METROPOLITAN GOVERNMENT OF NASHVILLE AND DAVIDSON COUNTY

STAFF RECOMMENDATION
1005 Acklen Avenue
July 15, 2020

Application: New Construction—Addition
District: Waverly-Belmont Neighborhood Conservation Zoning Overlay
Council District: 07
Base Zoning: R8
Map and Parcel Number: 10509020200
Applicant: Martin Wieck, Nine12 Architects
Project Lead: Melissa Baldock, melissa.baldock@yahoo.com

Figure 5. The c. 1968 property assessor photo of 1005 Acklen Avenue, showing the historic dormer.

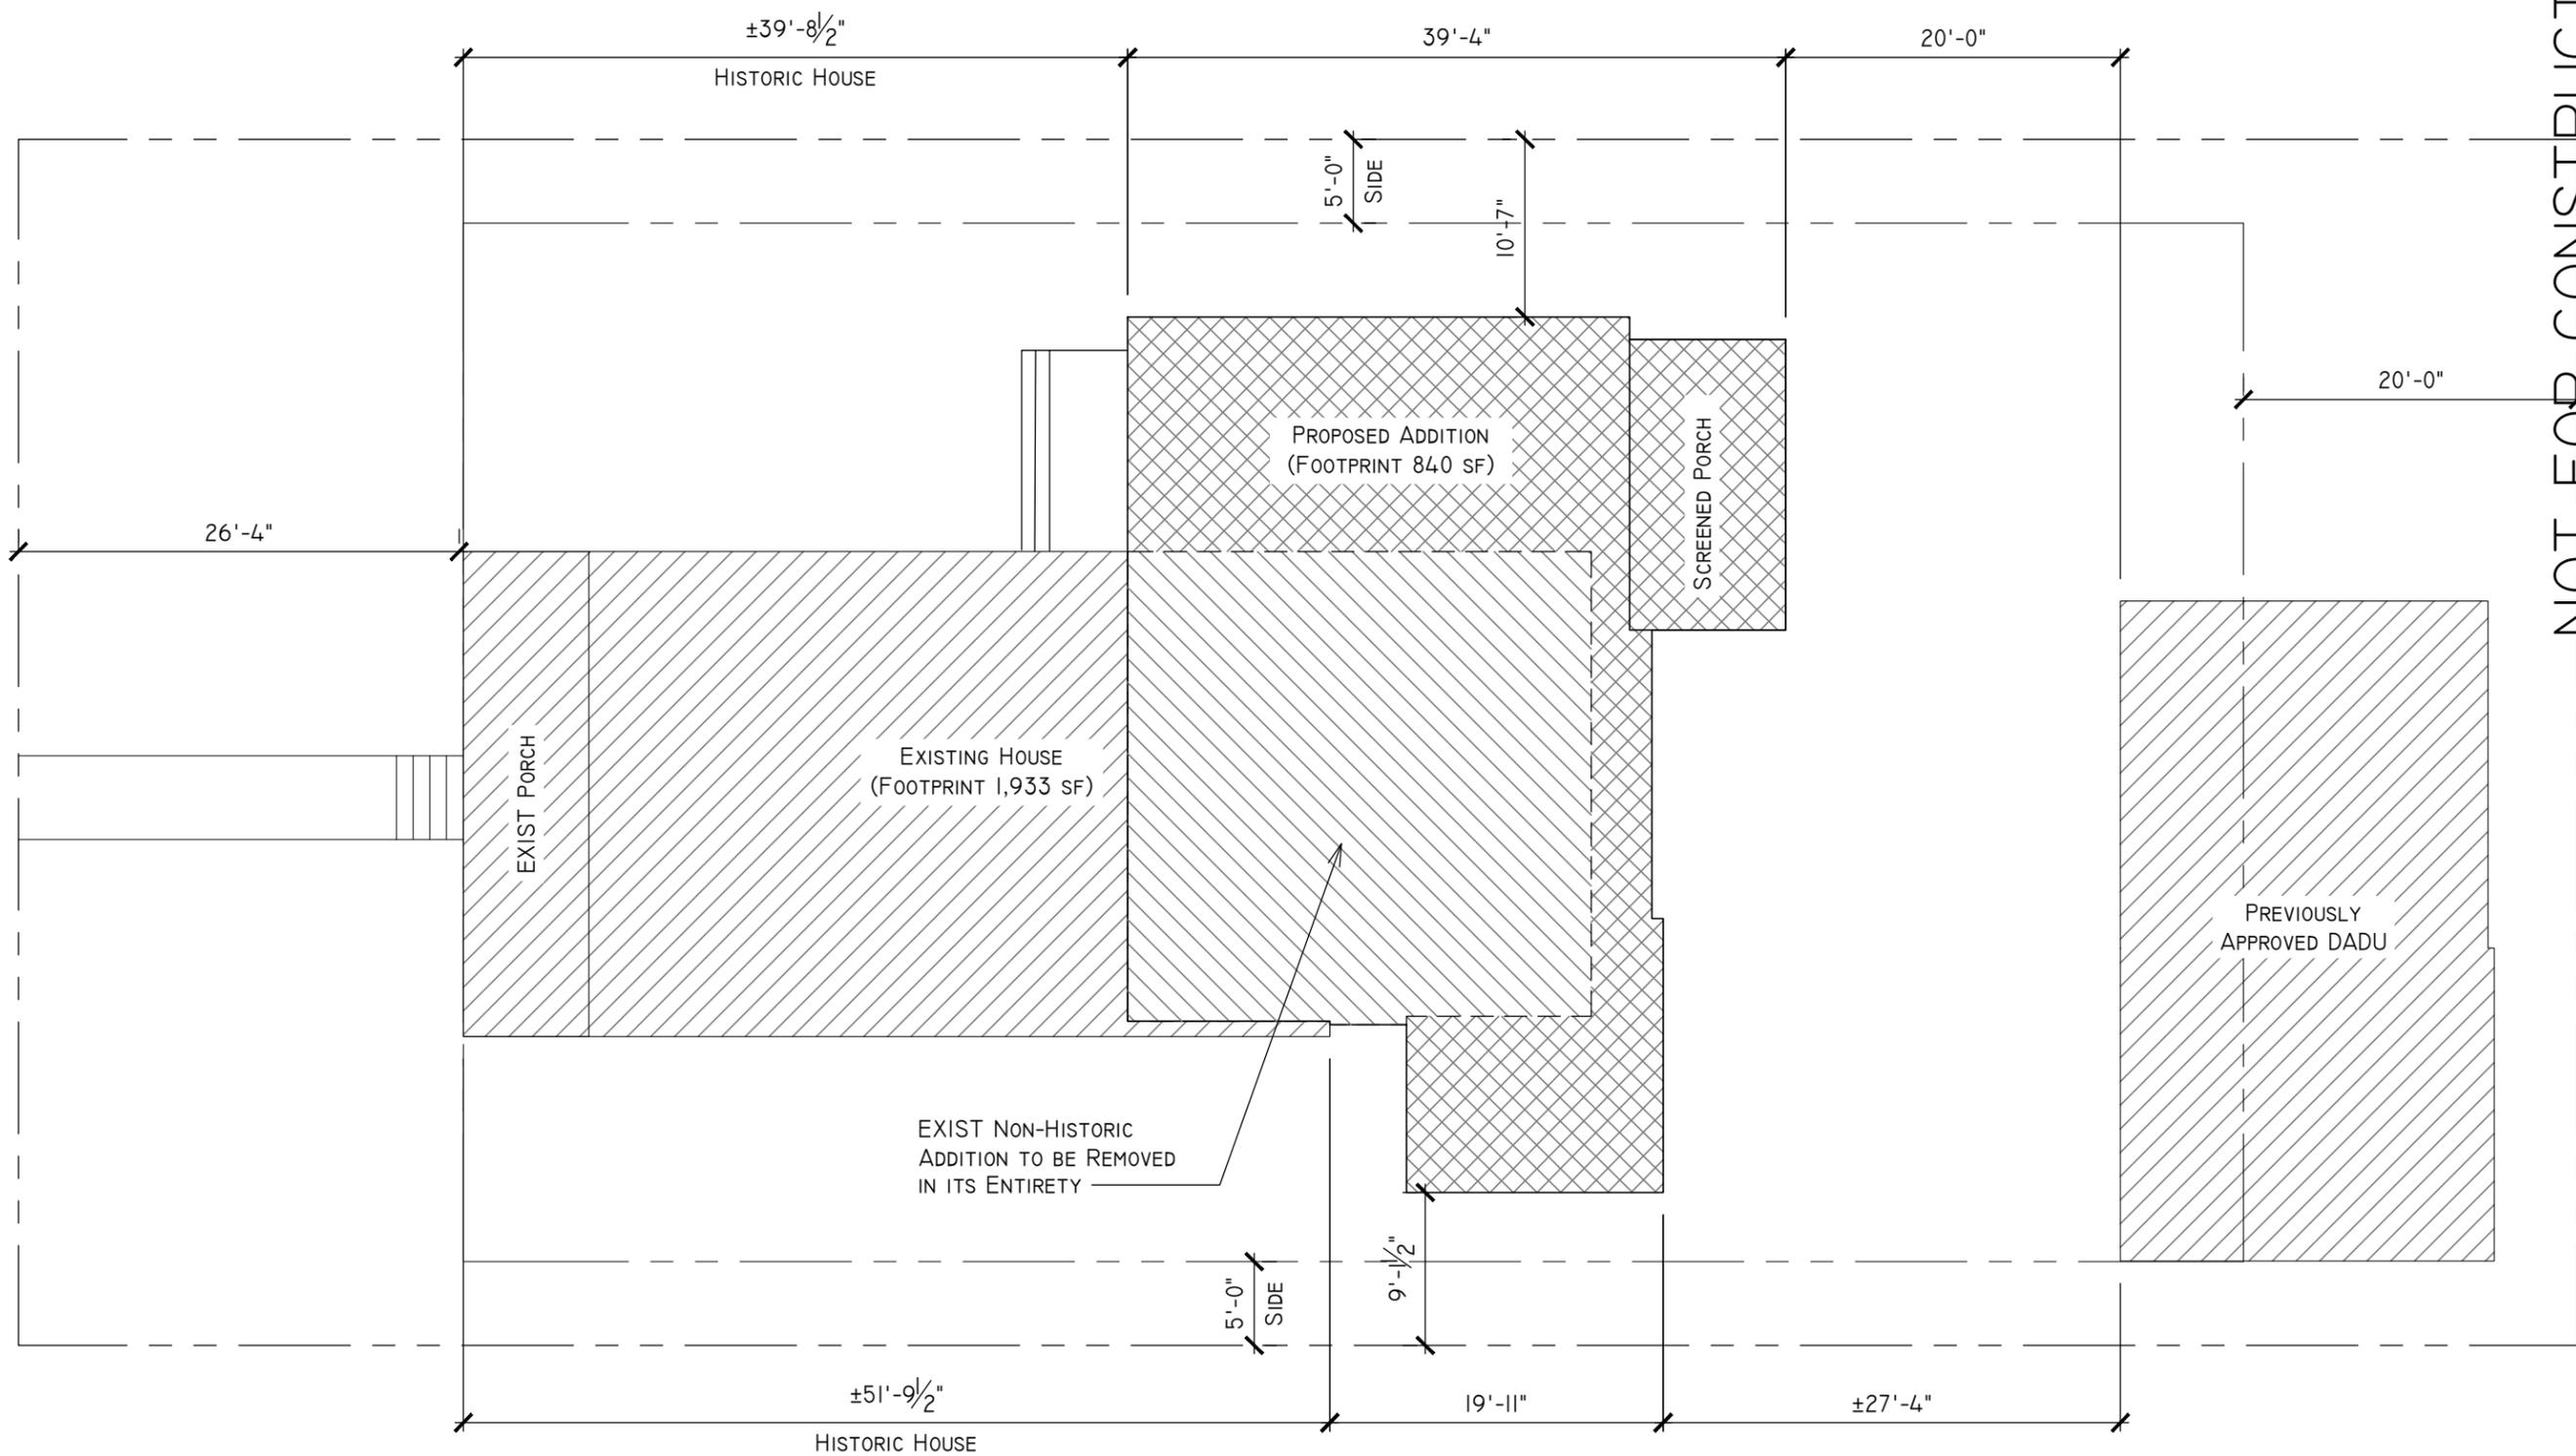
On the front façade, the applicant plans to construct a shed dormer with a slope of approximately 3/12. Typically, front dormers are not allowed on historic houses in the

Waverly-Belmont Neighborhood Conservation Zoning Overlay. However, in this case, the c. 1968 Property Assessor photo shows that historically there was a small shed dormer on the front slope of the roof. The proposed new front dormer will be similar in roof form, scale, and design to the historic dormer, and staff therefore finds it to meet the design guidelines. Overall, staff finds that the proposed roof forms are compatible with the historic house's roof form.

EXTERIOR
 ELEVATIONS

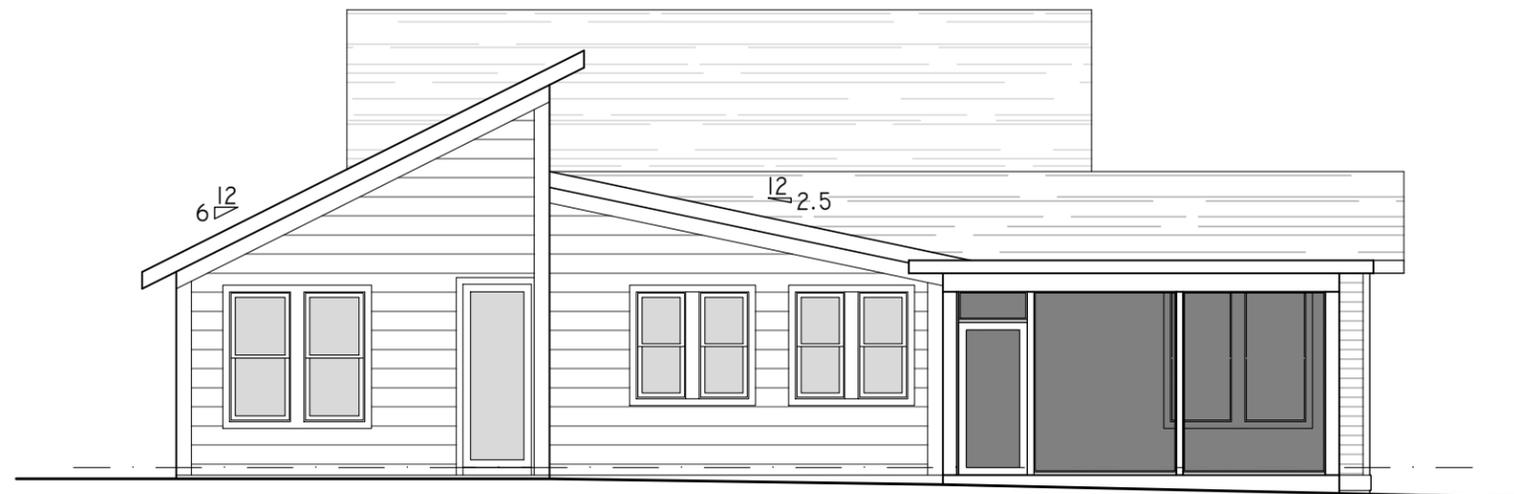
The architect's drawings show ten-inch (10") lap siding on the right side of the addition. Staff finds that the use of ten-inch lap siding is more than as an accent material and recommends that the siding mostly have a five inch (5") reveal, with some ten inch (10") reveal being appropriate as an accent only.

With the condition that the lap siding have a reveal of five inches (5") or less and with staff's approval the roof shingle color and all windows and doors, staff finds that the addition meets Sections III.D. and IV. of the design guidelines.

1. The lap siding have a maximum reveal of five inches (5”) or less;
2. Staff approve all windows and doors and the roof shingle color prior to purchase and installation; and
3. The HVAC be located behind the house or on either side, beyond the mid-point of the house.
